Coronado
Business Class M2
> Cascadia
108SD/114SD

**Freightliner
Service Bulletin**

Fig. 1, Cascadia Rear Hood Supports

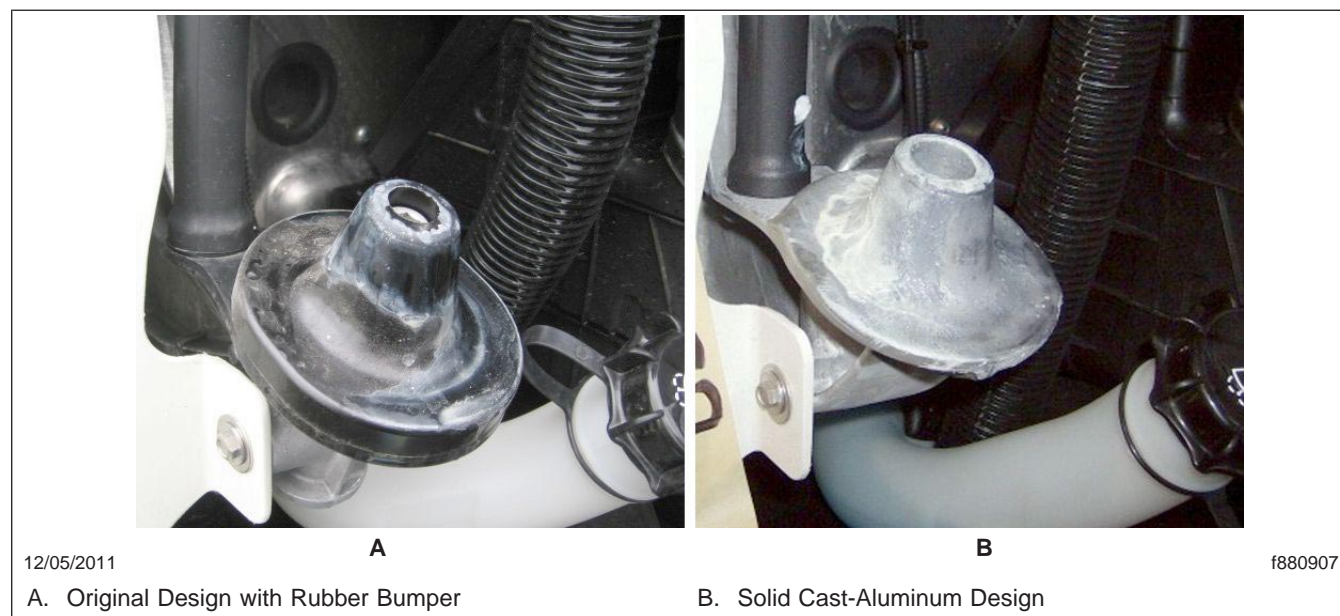
Cascadia vehicles built between August 29, 2011 and November 15, 2011 are equipped with solid cast-aluminum rear hood supports ([Fig. 1](#), Ref B). These vehicles may produce clunking, rattling, rumbling, or banging sounds that are objectionable to customers. As needed, use the procedure in this bulletin to install insulating pads on the cab-mounted hood supports.

Fig. 2, Insulating Pad Installation

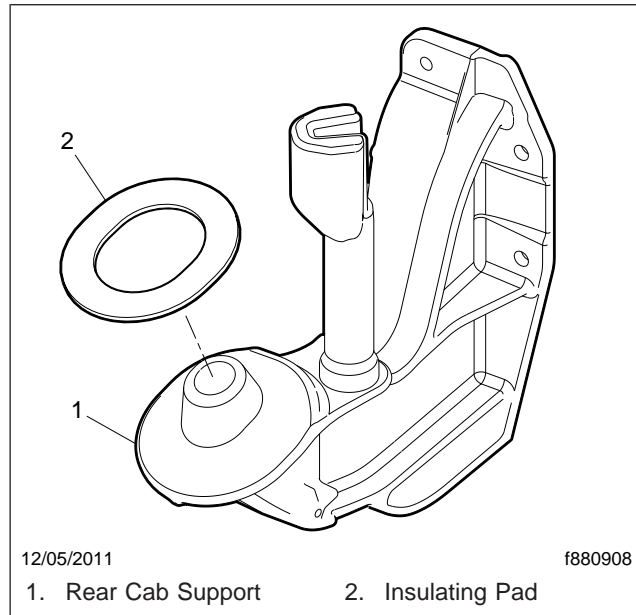
4. Remove the backing from the adhesive on the insulating pad, then attach it to the hood support. See [Fig. 2](#). Repeat on the other side of the vehicle.

NOTE: Do not apply grease to the rear hood supports after the insulating pads are installed.
